LSD Dwight Rich Food Service

Bid Pack 2, Addendum No. 1

Narrative of Changes

Project Name:	Dwight Rich Food Service – Equipment Replacement & Renovation SO-1854	Date:	April 03, 2026
Project Location:	2600 Hampden, Lansing, MI 48911	Architect’s Project #:	25015929A
Owner/Client:	Lansing School District	Attention:	David Beckering
Issued to:	Beckering Construction	Email:	djb@beckering.com
City/State:	Grand Rapids, MI	Zip:	49548

FIRST FLOOR AND CEILING PLANS

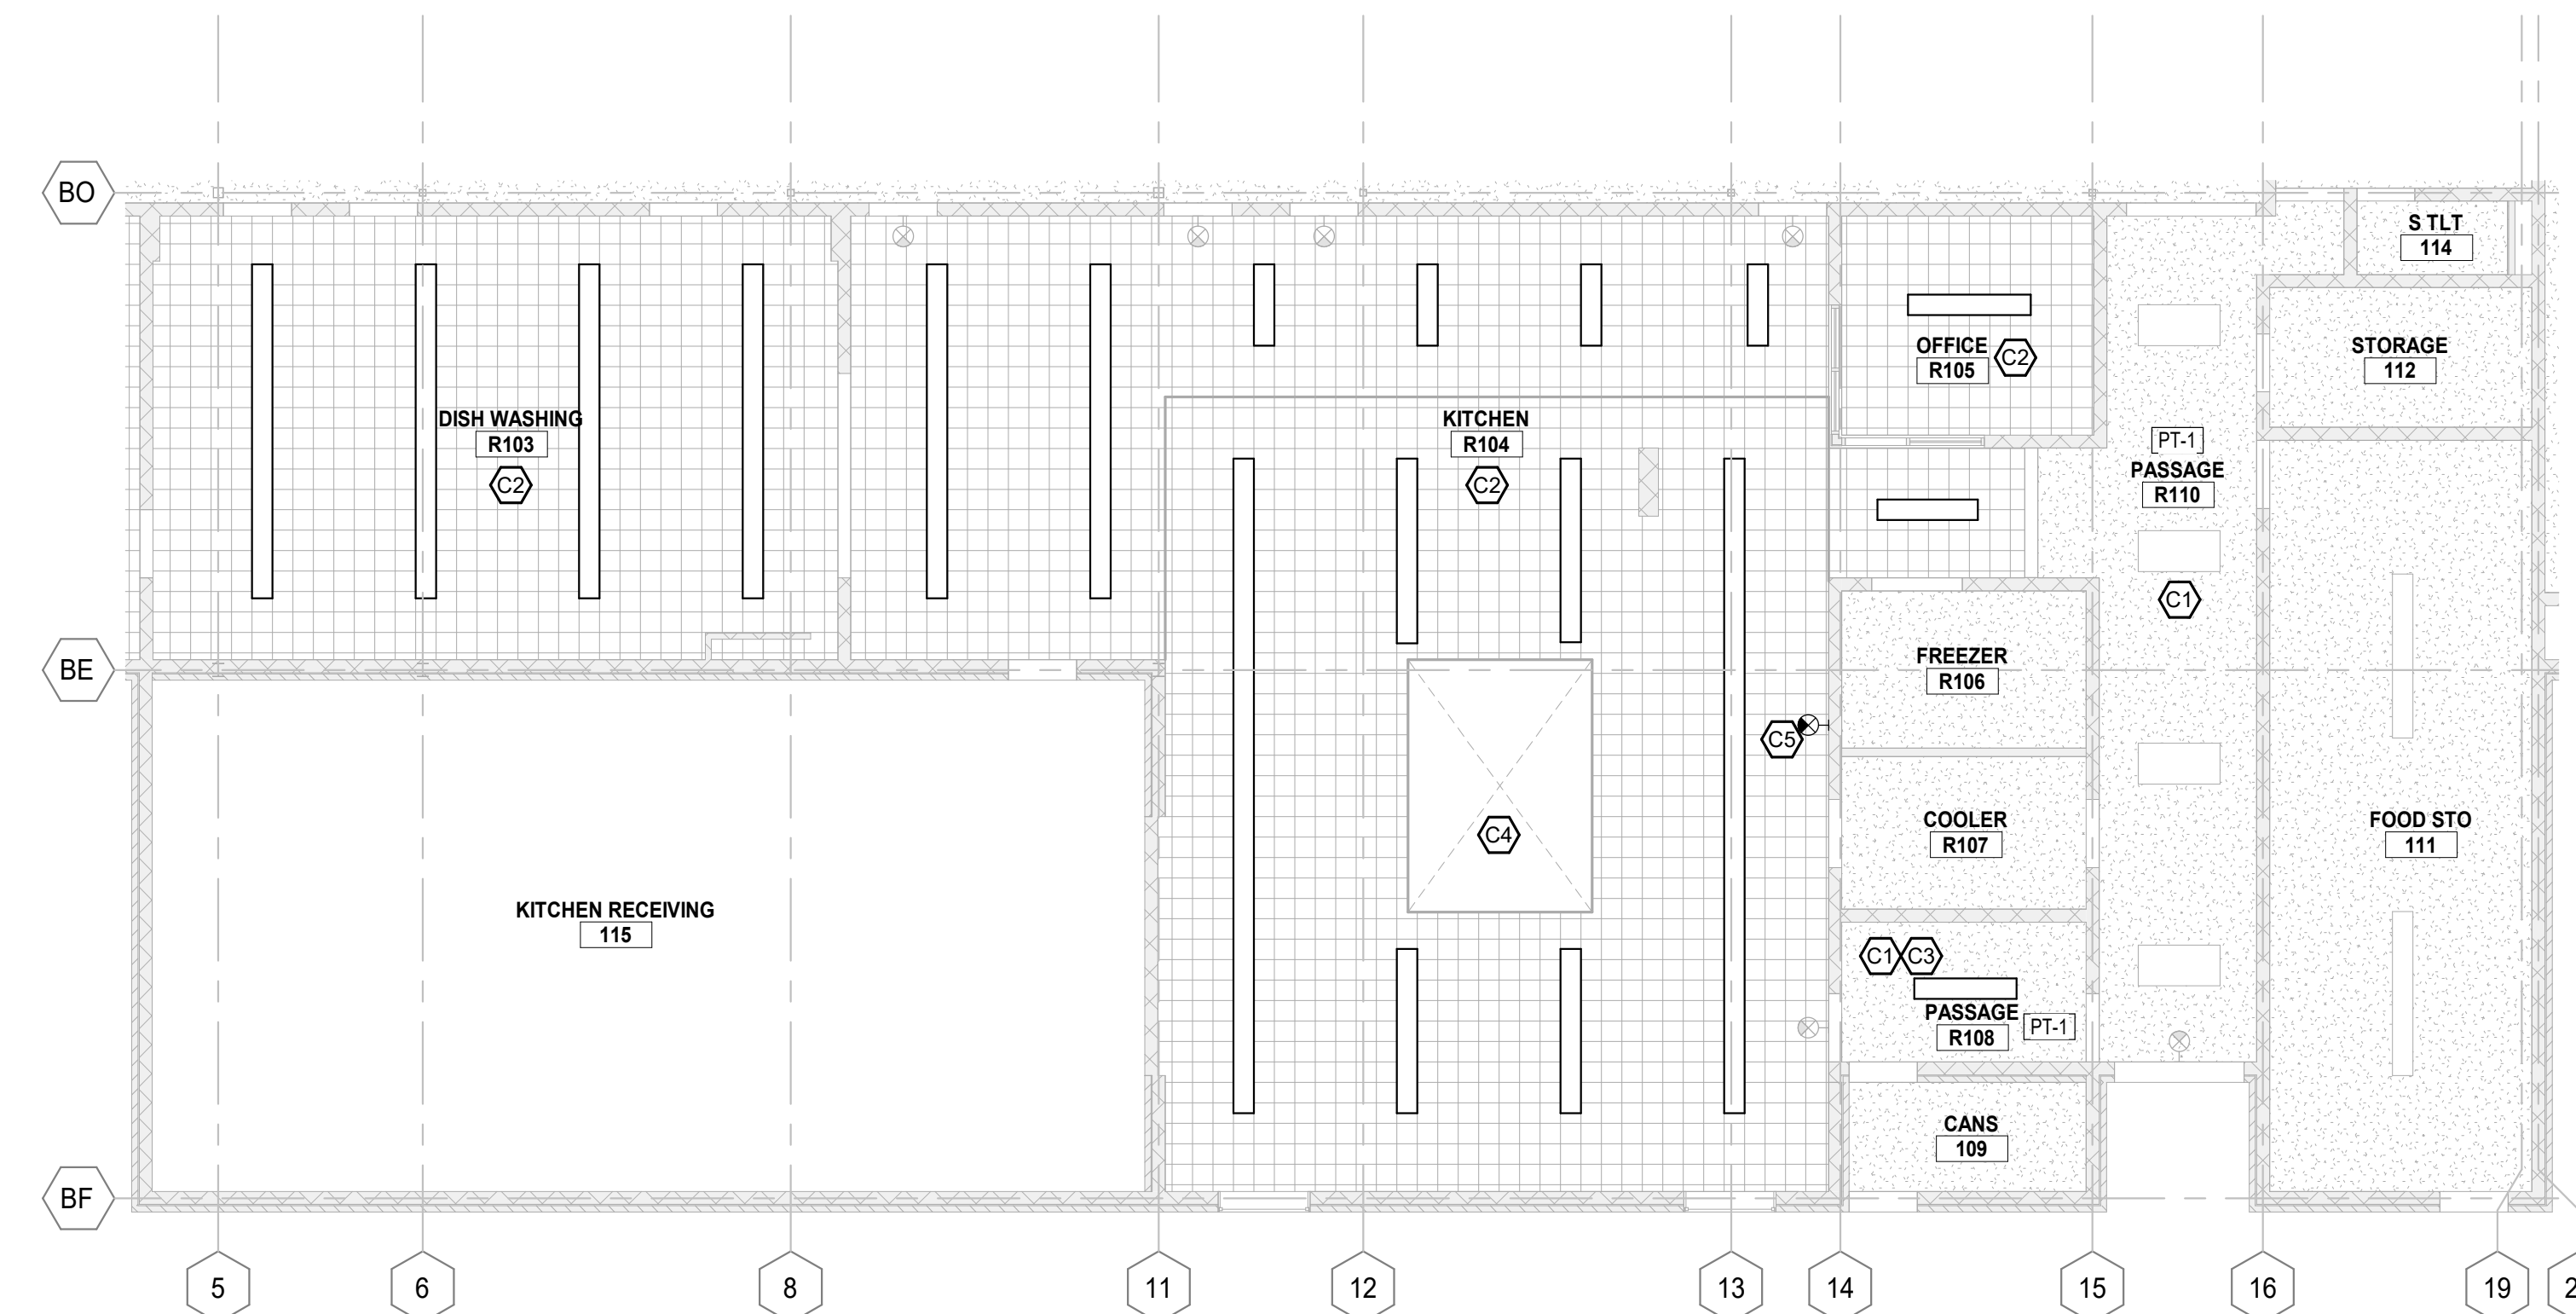
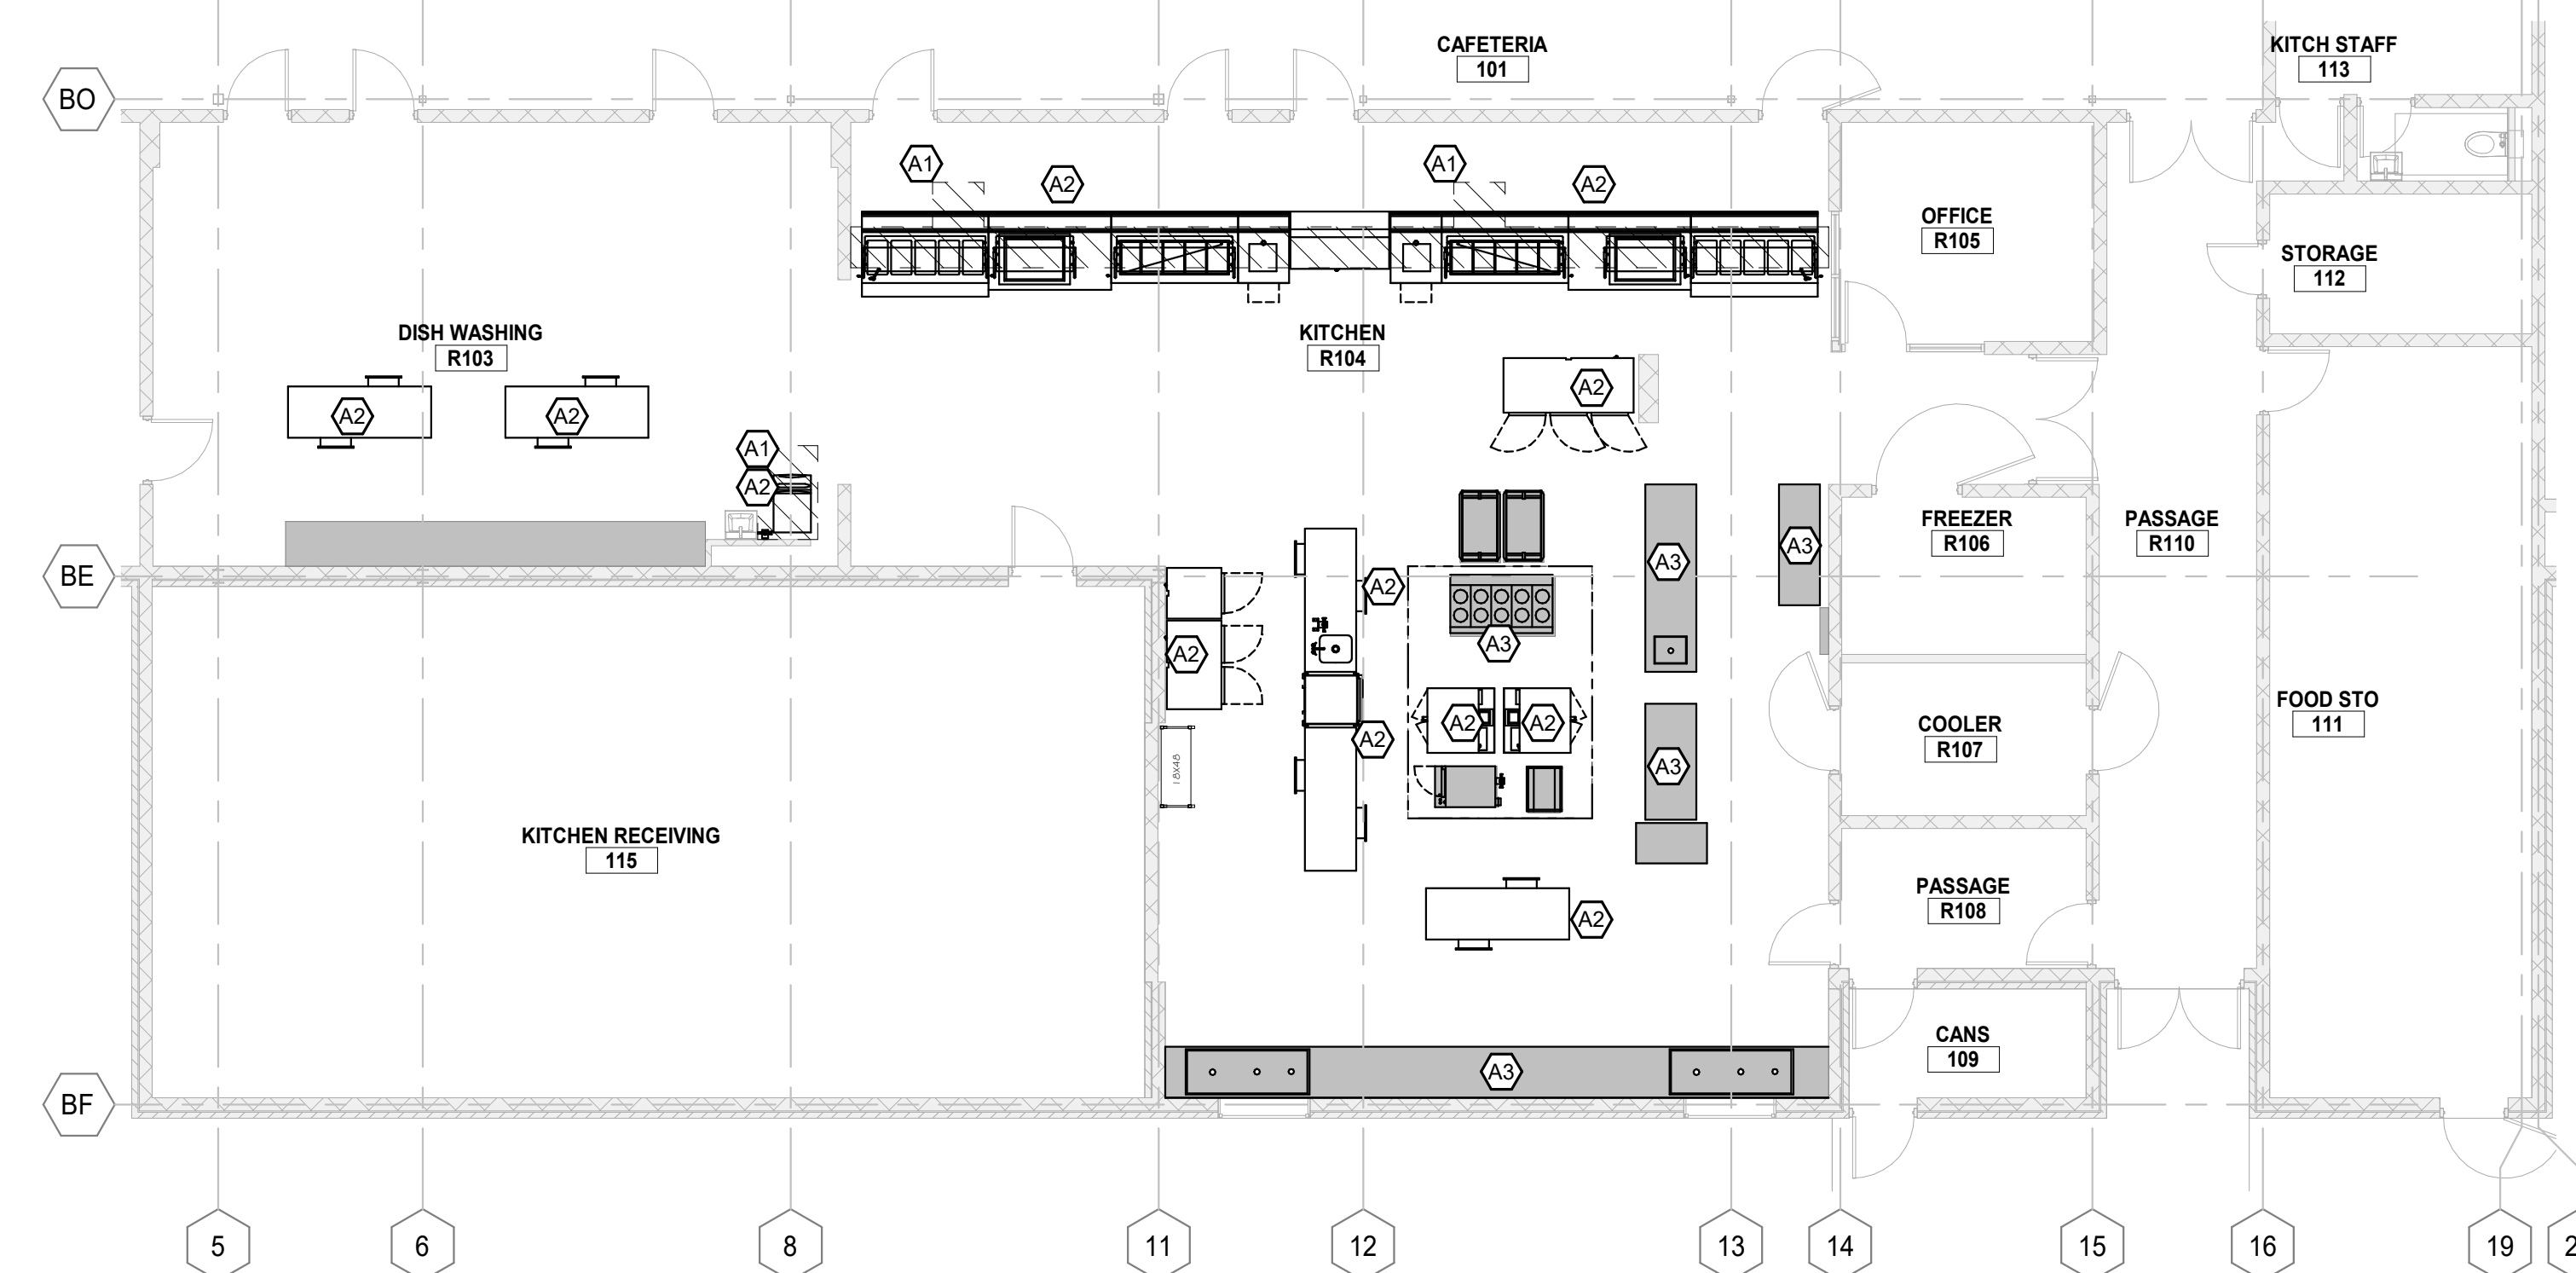
- A101 – FIRST FLOOR AND CEILING PLANS (Reissued)
 - Revised paint specifications

099123 - INTERIOR PAINTING:

- A. BASIS OF DESIGN MANUFACTURER: SHERWIN WILLIAMS. ALSO ACCEPTABLE: BENJAMIN MOORE AND PPG PAINTS.
- B. PREPARATION OF SURFACES TO RECEIVE PAINT: CLEAN, DRY, DULL, AND SOUND.

- C. PAINT SYSTEMS:
 - a. GYPSUM BOARD AND PLASTER:
 - PRIMER: PROMAR 200 ZERO VOC INTERIOR LATEX PRIMER, B28W2600
 - 1. 4.0 MILS WET, 1.0 MILS DRY.
 - INTERMEDIATE COAT: MATCH TOPCOAT.

- TOPCOAT: PROMAR 200 ZERO VOC INTERIOR LATEX EG-SHEL, B20-2600 SERIES.
 - 1. 4.0 MILS WET, 1.6 MILS DRY.
 - b. GYPSUM BOARD AND PLASTER CEILING:
 - PRIMER: LOXON CONCRETE & MASONRY PRIMER AS NEEDED ON NEW PLASTER

- INTERMEDIATE COAT: MATCH TOPCOAT
 - TOPCOAT: PRO INDUSTRIAL WATERBORNE ACRYLIC DRY FALL, FLAT, B42-80 SERIES
 - c. CMU:
 - PRIMER: EXTREME BOND PRIMER, B51 SERIES

- 1. 3.1 MILS WET, .9 MILS DRY.
 - ADHESION TEST: USE PRINCIPLES OF ASTM D3359 AFTER MINIMUM 7 DAY CURE TIME OF PRIMER TO ENSURE 90% OF COATING CONTINUES TO ADHERE. CONTACT COATINGS MANUFACTURER FOR ASSISTANCE AS NEEDED.

- INTERMEDIATE COAT: MATCH TOPCOAT.
 - TOPCOAT: PRO INDUSTRIAL PRE-CAT EPOXY ED-SHEL, K45-2150 SERIES.
 - 1. 4.0 MILS WET, 1.6 MILS DRY PER COAT.
 - d. HOLLOW METAL FRAMES AND DOORS:

- PRIMER: PRO INDUSTRIAL PRO CRYL UNIVERSAL PRIMER, B66-310 SERIES.
 - 1. 5.0 TO 10 MILS WET, 2.0 TO 4.0 MILS DRY.
 - INTERMEDIATE COAT: MATCH TOPCOAT.
 - TOPCOAT: PRO INDUSTRIAL ACRYLIC SEMI-GLOSS COAT, B66-650 SERIES.

- 1. 2.5 TO 4.0 MILS DRY PER COAT.
- D. COLORS: REFER TO BASIS OF DESIGN.
